## Product Change Notification / NTDO-14VTWR800

CCB 4395.001 Final Notice: Qualification of MMT as additional assembly site for selected Micrel SY5805xAUMG, SY880x3LMG, SY880x3CLMG and SY88xxxALMG device families available in 16L VQFN (3x3x1.00mm) package.

**CCB 4395.001**  
**Pre and Post Change Summary**  
**PCN # NTDO-14VTWR800**

# Lead frame Comparison

## Pre Change UNIS

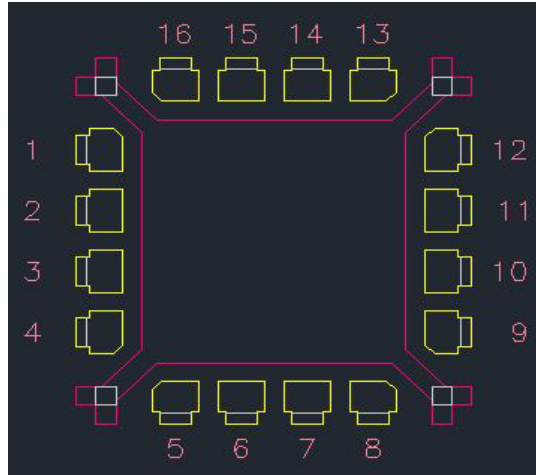
<b>Lead frame Material</b>	C194
<b>Lead frame DAP surface prep</b>	NiPdAu
<b>Lead frame lead-lock</b>	None

## Post Change MMT

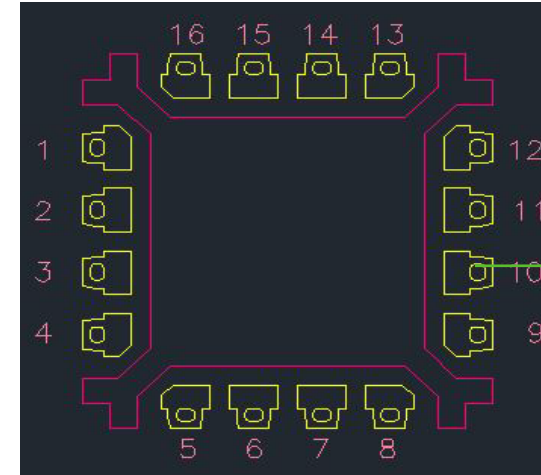
<b>Lead frame Material</b>	C194
<b>Lead frame DAP surface prep</b>	NiPdAu
<b>Lead frame lead-lock</b>	Yes

Note: The lead lock hole fills with mold compound during the assembly process and provides improved protection against moisture penetration around the interface edges between pins and mold compound.
